NOTICE OF DECISION

Permit No: #234

Address: 345-355 Fresh Pond Parkway

Application: Special Permit for a waiver of the Parkway Overlay District development standards (Section 20.63.7), and Special Permit for a waiver of setback requirements (Article 6.000), to demolish existing underutilized 6,325 square foot retail building and construct a 19,400 square foot two-floor retail and office building.

**MODIFIED
SITE
PLAN**

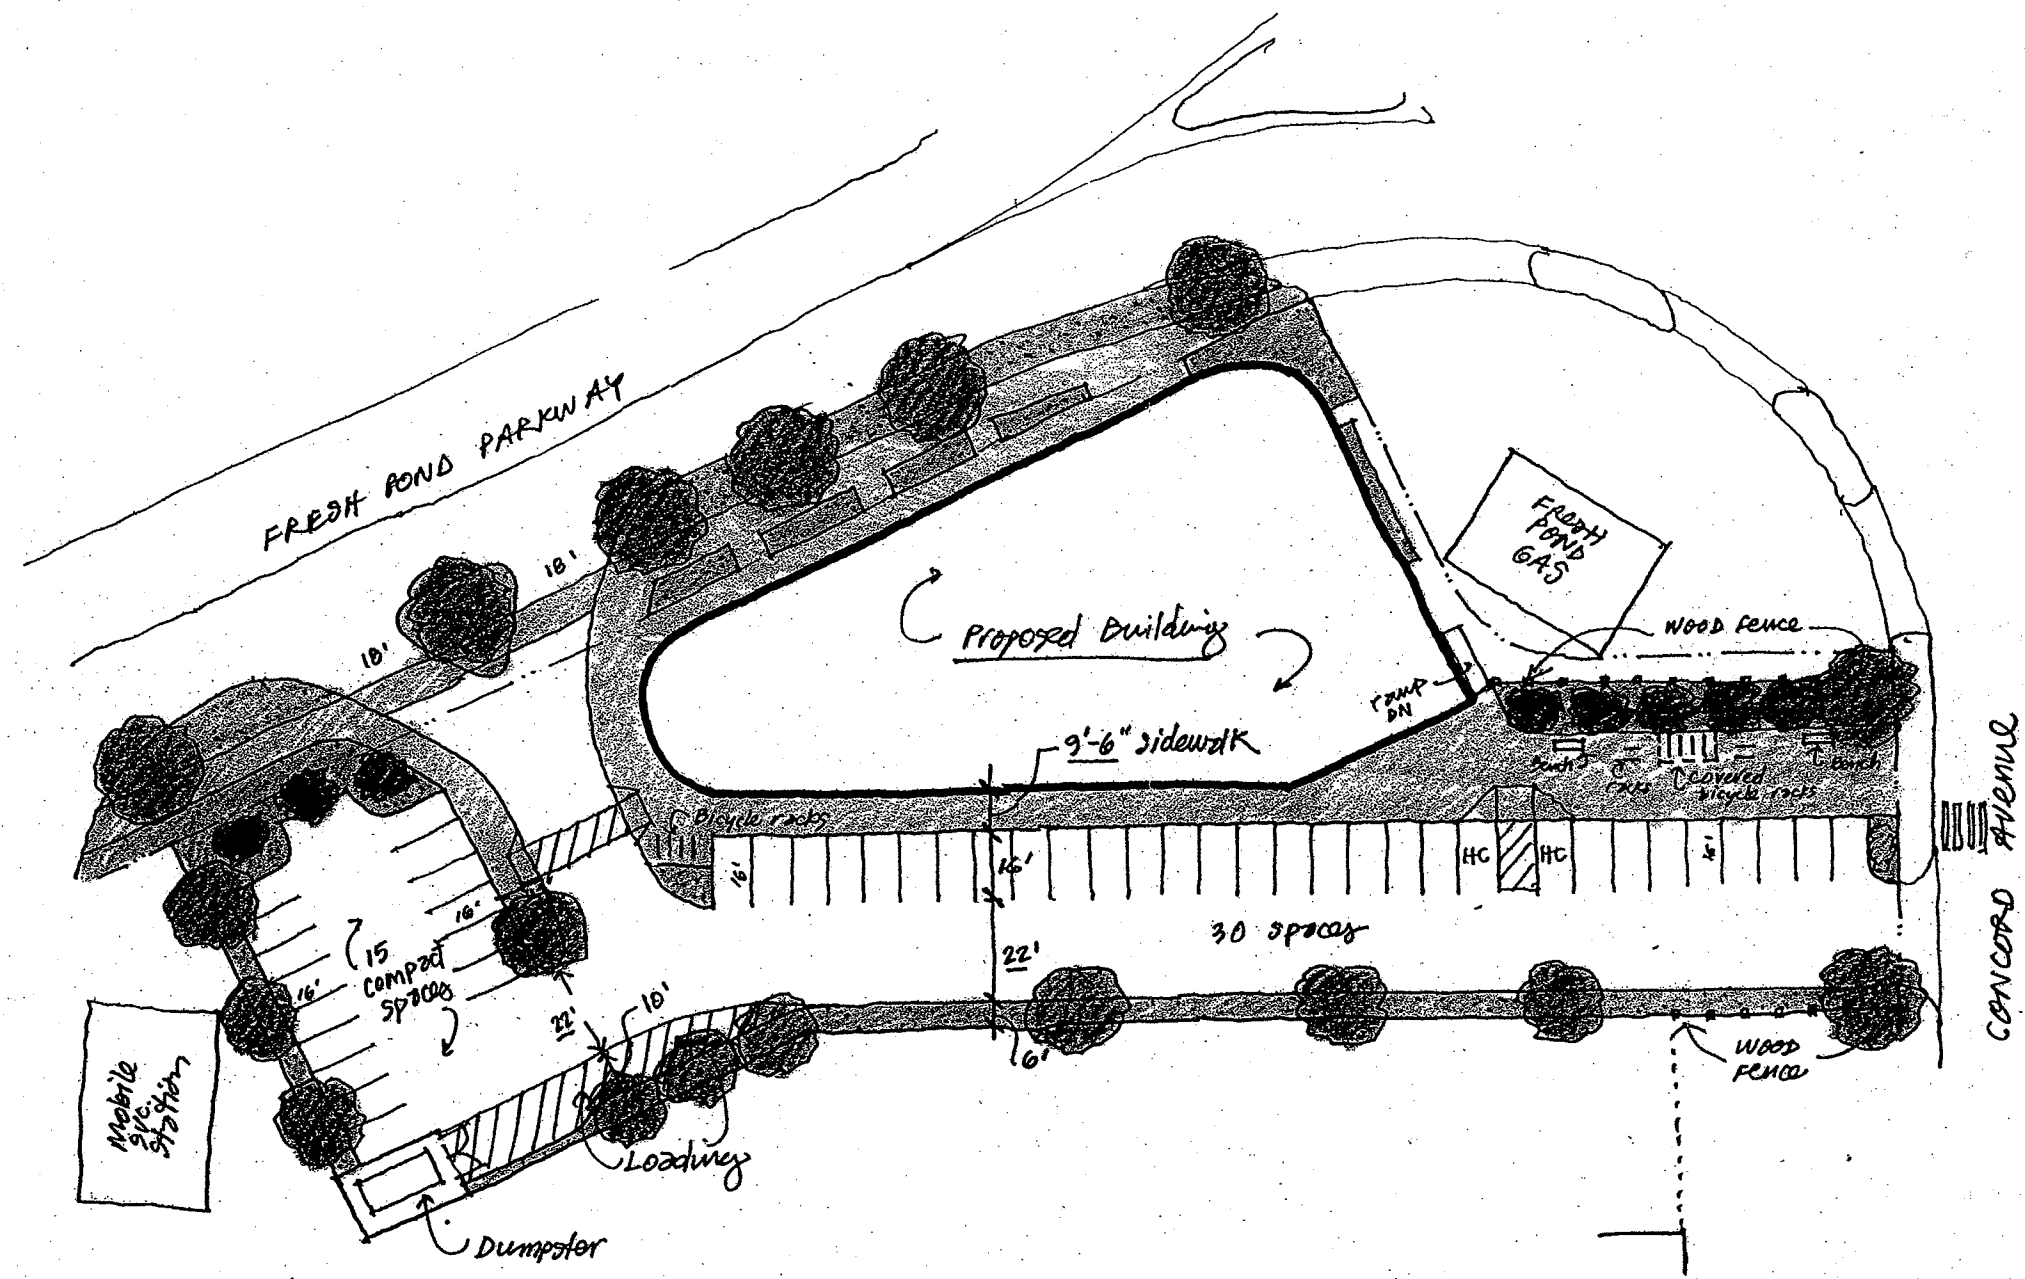
On January 22, 2008 at the request of the Board, Fresh Pond Real Estate Development LLC, submitted a Modified Site Plan for the project. The Modified Site Plan showed a wider proposed sidewalk along the building, relocated dumpster location away from Concord Avenue, additional landscaping on Fresh Pond Parkway and the parking spaces further set back, additional bike racks at Concord Avenue, and a 6' wood fence buffering Fresh Pond Gas.

The sidewalk along the east façade (rear) of the building was increased to nine (9) feet six (6) inches, by making the parking spaces shorter [sixteen (16) feet]. This change was at the request of the Planning Board and it is the Board's view that the compromise in dimensions is to the benefit of pedestrians coming to the site and not a detriment to the operation of the accessory parking facility.

At the suggestion of the Board the proposed loading bay was relocated to the rear of the parking lot in the southeast corner of the property away from street activity. While the bay is within 50 feet of a Residence B district, the adjacent use is a National Guard installation, which will not be adversely affected. The bay will also be heavily screened. It is not expected that the bay will be heavily used by large commercial vehicles.

MODIFICATIONS:

1. WIDER SIDEWALK ALONG BUILDING
2. SHORTER PARKING SPACES IN FRONT OF SIDEWALK (16' DEPTH)
3. RELOCATED DUMPSTER TO SOUTHEAST CORNER OF PROPERTY
4. COMPACT CAR PARKING SET BACK FURTHER FROM FRESH POND PARKWAY
5. ADDITIONAL BICYCLE RACKS AT CONCORD AVE ENTRANCE
6. 6' WOOD FENCE BUFFERING FRESH POND GAS
